KDS Apparels Ltd. (Extension)

21 July 2022

Block-C Building: Partially 6 storied (G+5) building.

Deflection at Inverted beam of OHWT

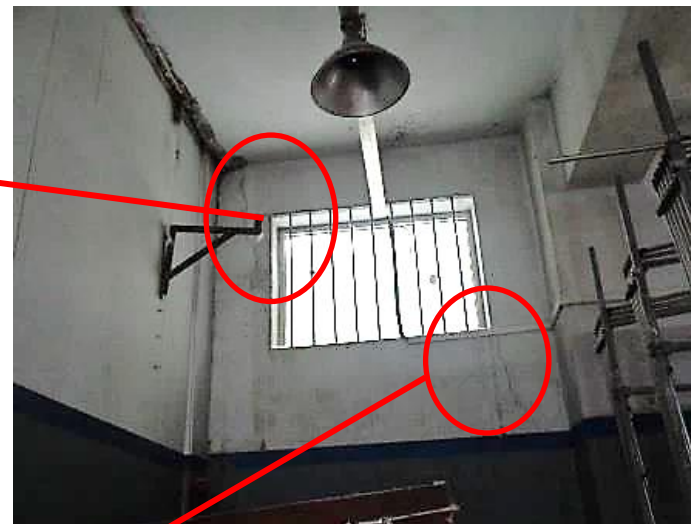
Deflection at Inverted slab of OHWT was observed. Building engineer is required to check whether the deflection cross the normal design limit or not and take necessary action as per engineer's guideline.

Item No.	Observation	Recommended Action Plan	Recommended Timeline
01	Deflected of slab under the overhead water tank. [Block-C (RC part)]	Building engineer is required to check the adequacy of OHWT slab to confirm deflection is within the allowable limit.	6-weeks
02	Deflected of slab under the overhead water tank. [Block-C (RC part)]	Produce and actively manage a loading plan for the OHWT and maintain accordingly.	6-weeks
03	Deflected of slab under the overhead water tank. [Block-C (RC part)]	Carry out remedial works if required.	6-months
04	Deflected of slab under the overhead water tank. [Block-C (RC part)]	Continue to implement the load management plan.	6-months
05	Crack on brick wall. [Block-C (RC part)]	Building engineer is required to check the extent of crack and suggest proper repair methodology.	6-weeks
06	Crack on brick wall. [Block-C (RC part)]	Carry out remedial works.	6-months

Yarn store (2nd Floor), Steel part

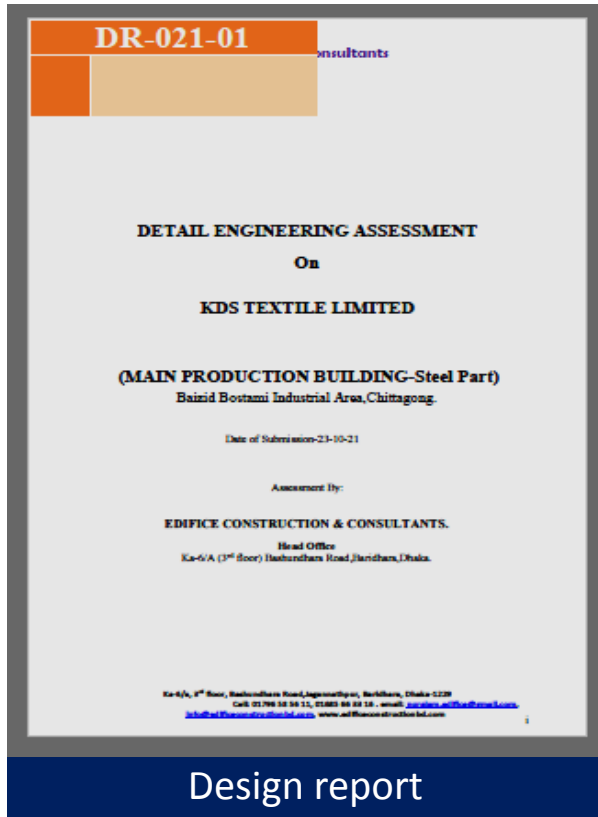
As per prepared load plan, allowable live load limit of 2nd floor (Yarn store) is 7.5 kPa. But, at the time of inspection calculated localize loading was found more than 7.5 kPa.

Item No.	Observation	Recommended Action Plan	Recommended Timeline
07	Localized high loading on 2nd floor. [Block-C]	Factory engineer to investigate the floor loading arising from storage and advise on any necessary alterations taking account of floor capacity and column capacity.	6-weeks
08	Localized high loading on 2nd floor. [Block-C]	Check the adequacy of steel storage rack.	6-weeks
09	Localized high loading on 2nd floor. [Block-C]	Adequately anchor and brace all non-structural elements to resist earthquake forces to comply with the BNBC.	6-weeks
10	Localized high loading on 2nd floor. [Block-C]	Make any structural alterations as advised by factory engineer.	6-months
11	Localized high loading on 2nd floor. [Block-C]	Continue to implement the load management plan.	6-months
12	Information missing in the DEA report. [Block-C (Steel part)]	Factory is required incorporate all type of adequacy check in the DEA report and the report should be in compliance with section 1.9.1 of BNBC (part 6).	6-weeks
